Re: PUCO Case No. 15-1682-EL-BTA
Biers Run-Hopetown-Delano 138kV Transmission Line Amendment Project

**AMENDMENT TO THE BIERS RUN-HOPETOWN-DELANO
138 kV TRANSMISSION LINE PROJECT**

Case Number 15-1682-EL-BTA

**AMENDMENT FIGURE 04-1
CONSTRAINTS MAP**

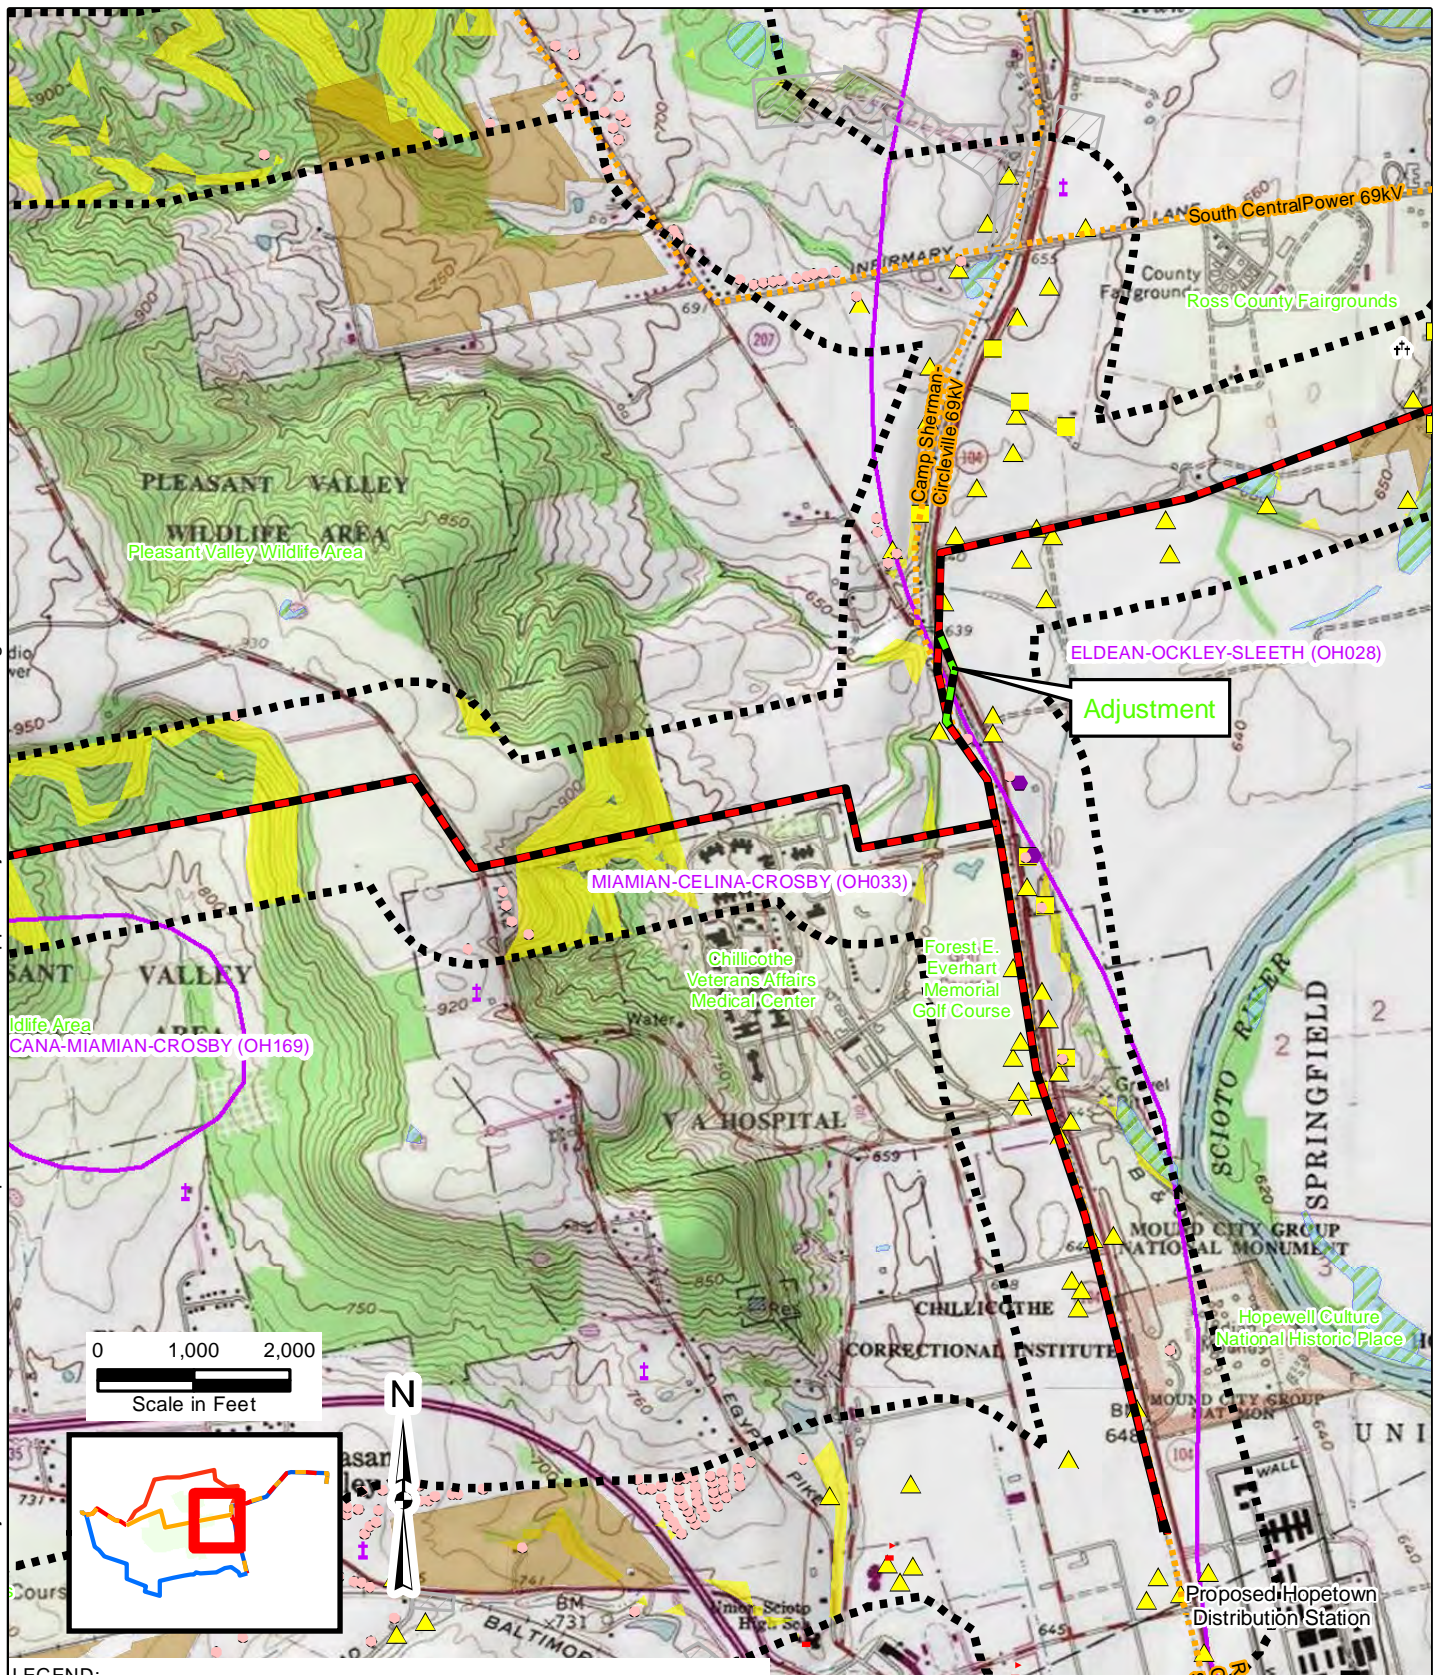
The adjusted section of the OPSB Approved Route is located in Union Township in Ross County, Ohio. The alignment of the OPSB Approved Route and the proposed adjustment in this area of the Project are shown on Amendment Figure 04-1, Constraints Map.

The adjustment of the OPSB Approved Route is approximately 1,040 feet (0.20 mile) long and is located predominantly along State Route 104. The adjustment is located on four parcels with Parcel Numbers 370914008000, 370914009000, 370913270000, and 370914052000. The owner of parcels 370914008000 and 370914009000 is AEP, and the owner of parcels 370913270000 and 370914052000 is listed as Detillion Properties, LTD. The adjustment was done to accommodate a request by Detillion Properties, LTD to move the route more onto AEP land.

AMENDMENT FIGURE 07-1
ECOLOGICAL FEATURES

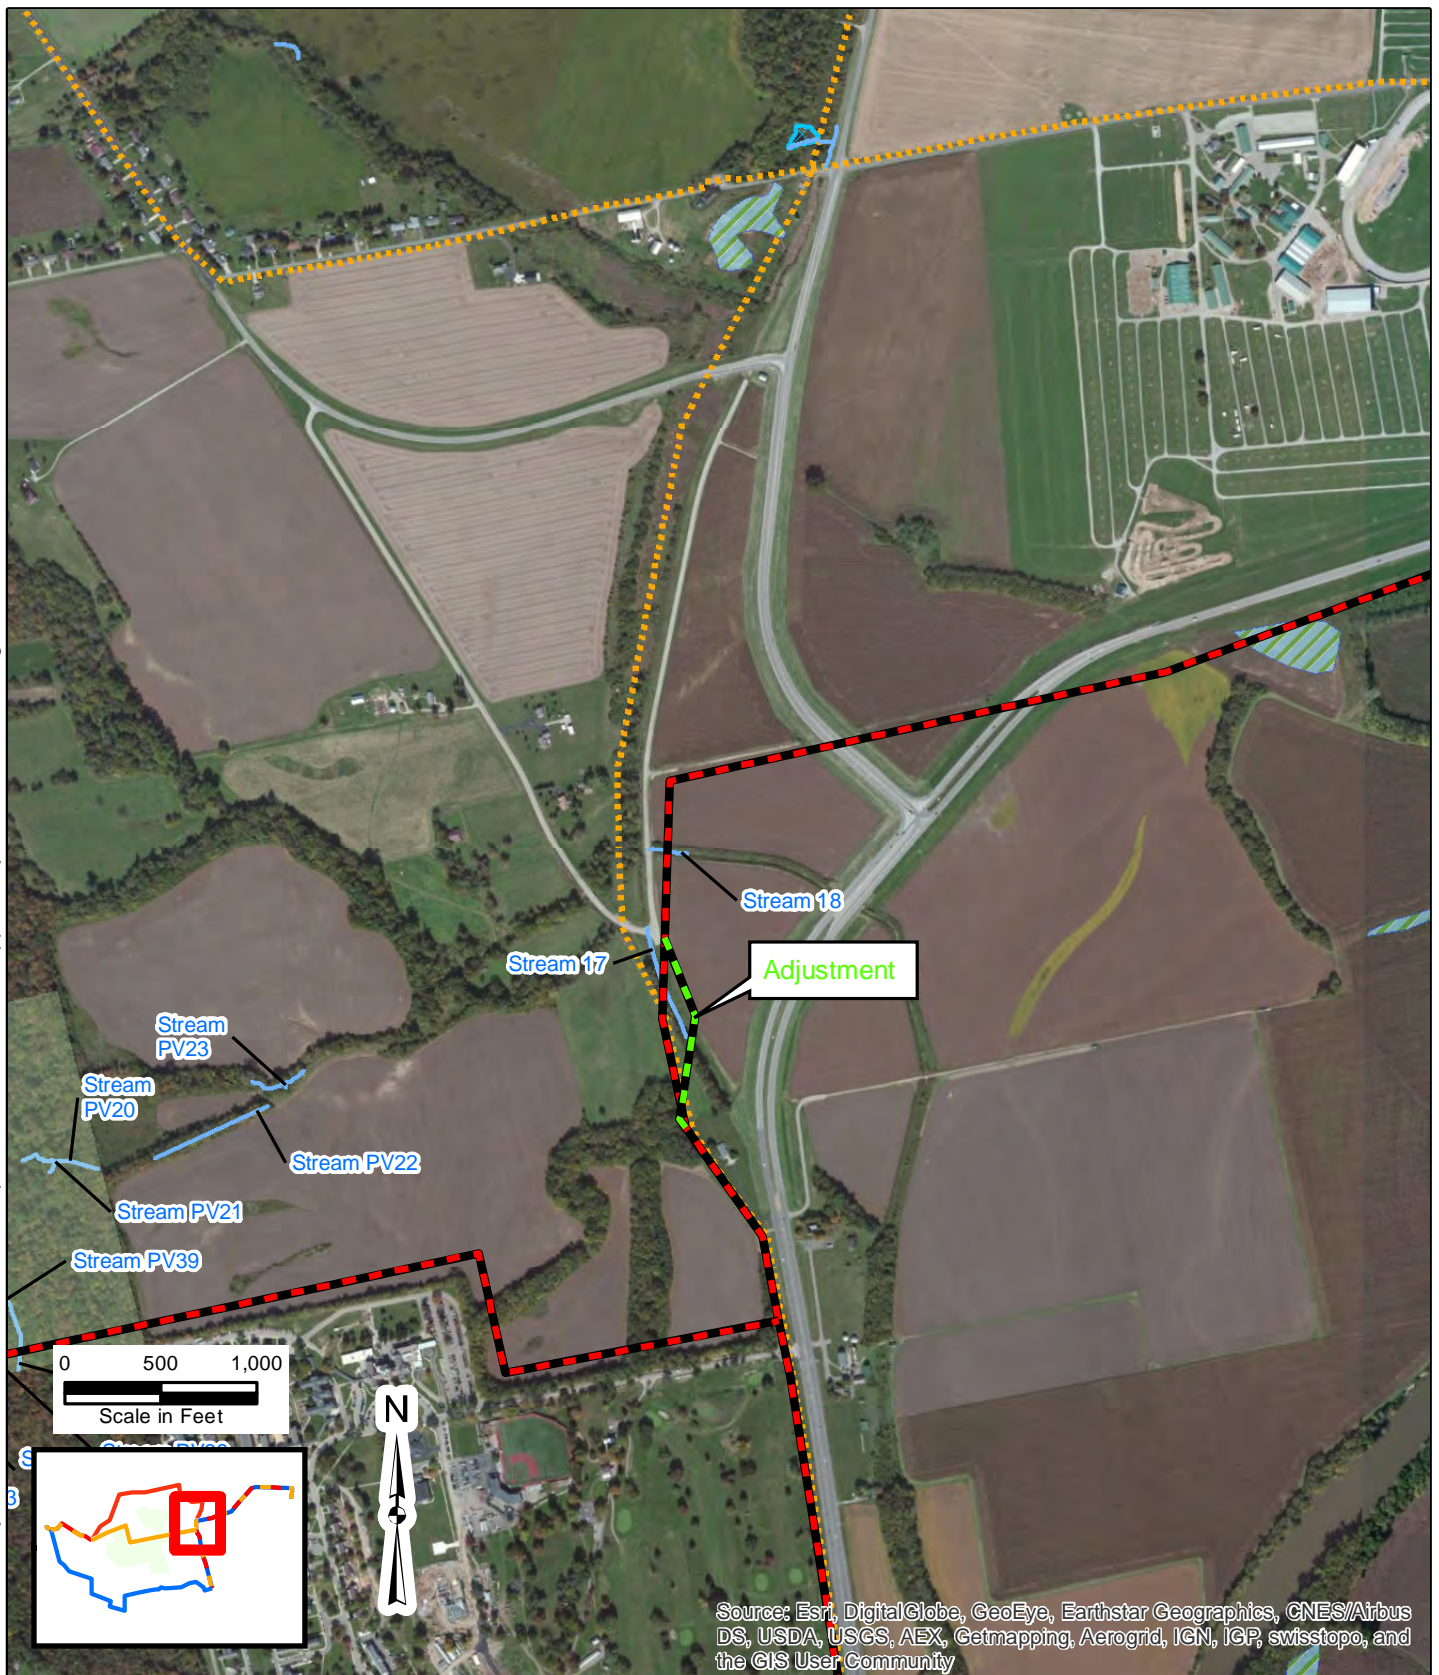
On behalf of AEP, URS conducted a field reconnaissance of the route adjustment. Table 07-1 Revision 3, was provided in the 3rd Supplement to the OPSB Application, dated July 31, 2014. No new stream crossings were identified. The length of Stream 17 within the proposed right-of-way is reduced from 258 feet to 36 feet by the adjustment. Amendment Figure 07-1 shows streams and wetlands along the adjustment and corresponding portions of the OPSB Approved Route.
